Design Review/Preservation Board
Sacramento, California

Subject: 502-504 10th Street
Multiple family rehabilitation

PROPOSAL: The applicant proposes the rehabilitation of existing apartment buildings, including a reduction from 17 to 11 units.

APPLC. NO. PB87-049

SOUTH SIDE ELEVATION

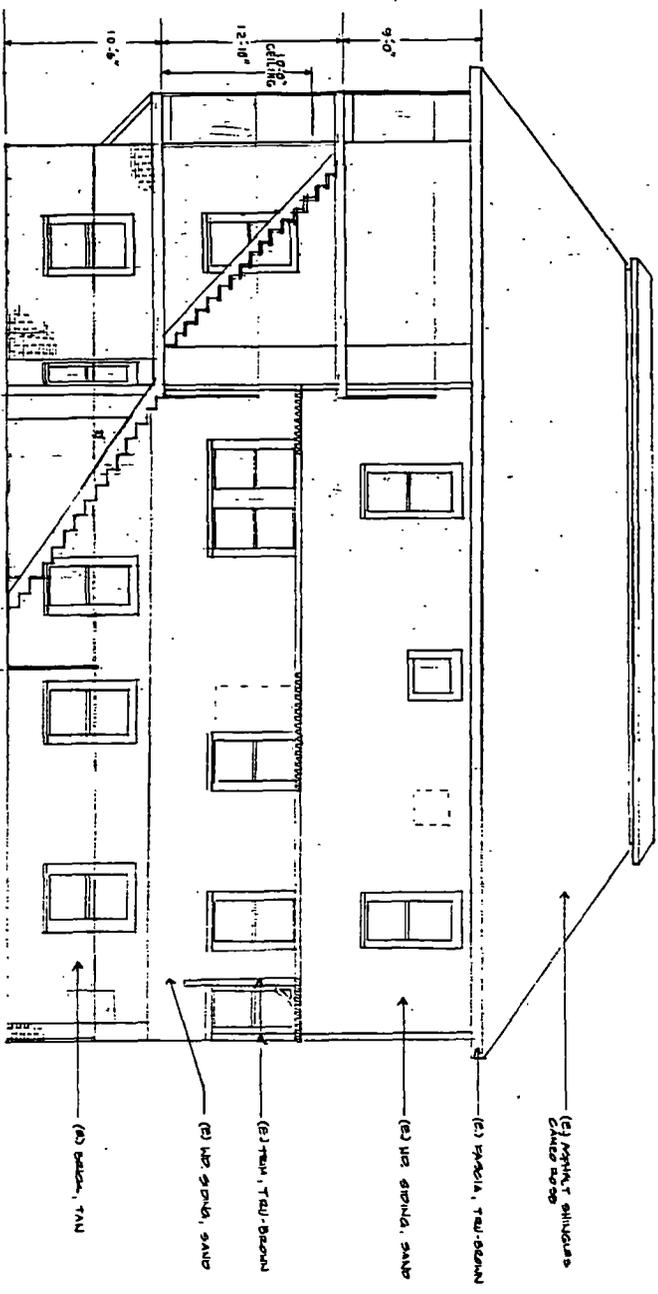
- h. The south elevation of 502 10th Street, as drawn, does not show the location of existing windows. New windows are proposed at the first floor elevation. The location of the new windows and the removal of existing windows should be reviewed and approved by staff. The new entry door to be placed in the existing ground level door opening should be a four panel steel door. The design should be reviewed and approved by staff.

- m. The south side of 504 10th Street is proposed to retain some existing windows and to remove other existing windows and replace them by new windows. It is not clear, in all instances, where existing windows may remain and where new windows may be placed. The ground floor portion of this elevation behind the existing stairs to the west, is not readily accessible for review in the field. The new fire escape stairway at this elevation has been shown. The stairway is proposed to have a solid wood baluster with a diamond shape decorative panel in each baluster position. Staff feels that the stairway should be redesigned to have 2 x 2 balusters with the appropriate top and bottom rail in place of the solid plywood railing and baluster as shown. The location of new windows and the retention of existing windows should be reviewed and approved by staff.

NORTH ELEVATION, 504 10TH ST.

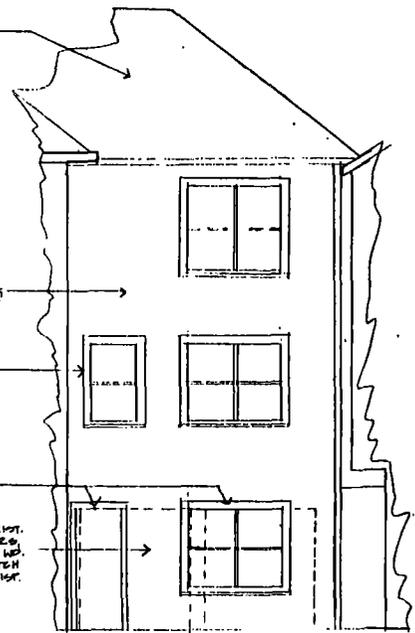
- n. 504 10th Street, north elevation, has some existing windows and an existing door proposed to be removed. The location and removal of the existing windows and/or door should be reviewed and approved by staff. The east elevation of this structure, as it faces the interior courtyard, currently has a ground level garage door with four existing windows above, two on the second floor and two on the third floor. The applicant proposes to remove the garage door and to replace it by a new doorway and window. This is acceptable to staff. The removal of existing windows and replacement with new windows on second and third floor level should be reviewed and approved by staff.

WEST (REAR) ELEVATION

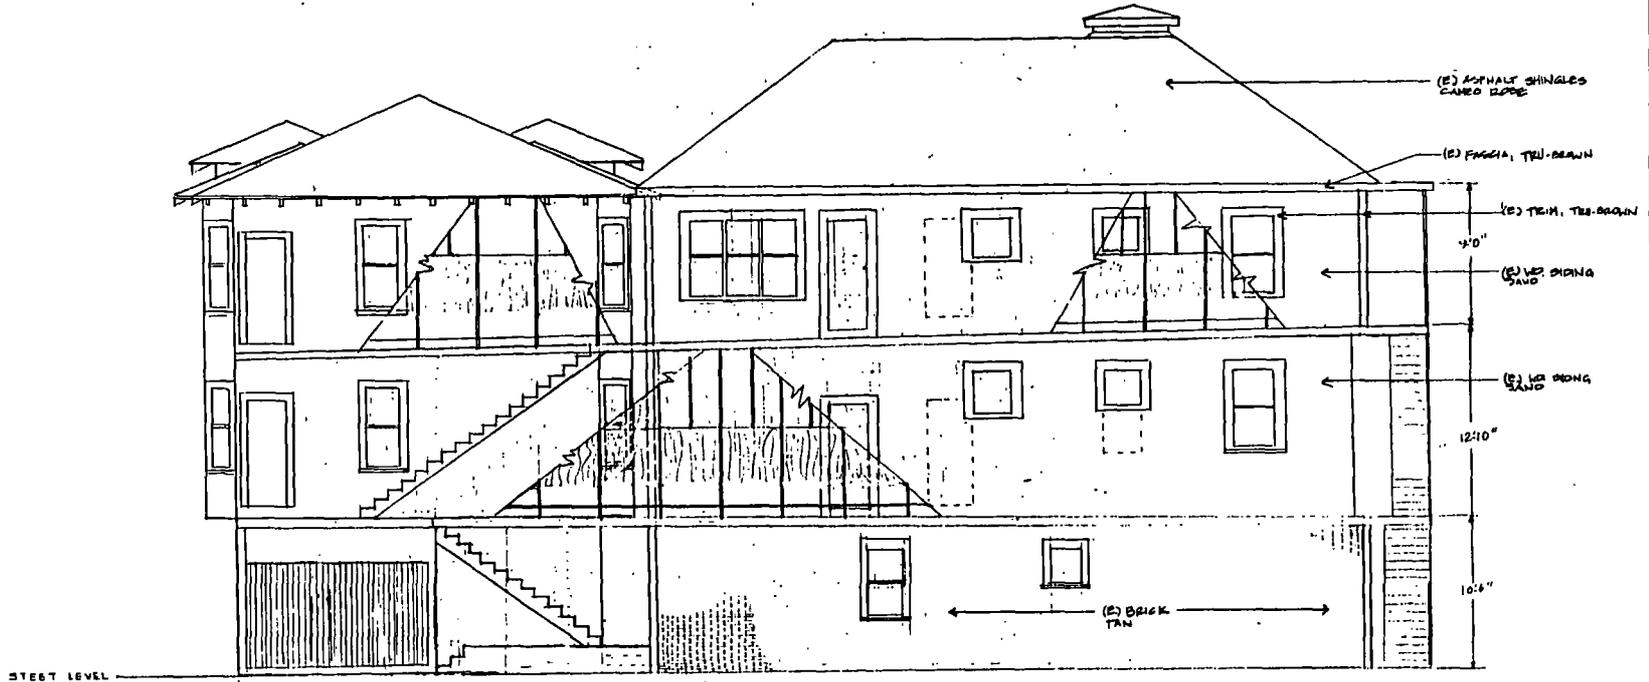
- o. The west rear elevation of both structures have the new stairway and fire escape systems shown. These stairways are suitable except for the treatment of the guard rail with solid plywood panels. Staff would recommend that these guard rails and balusters should be replaced with 2 x 2 baluster as recommended for the south elevation of the building. Any replacement or removal of existing windows or placement of new windows on the west elevation should be reviewed and approved by staff.
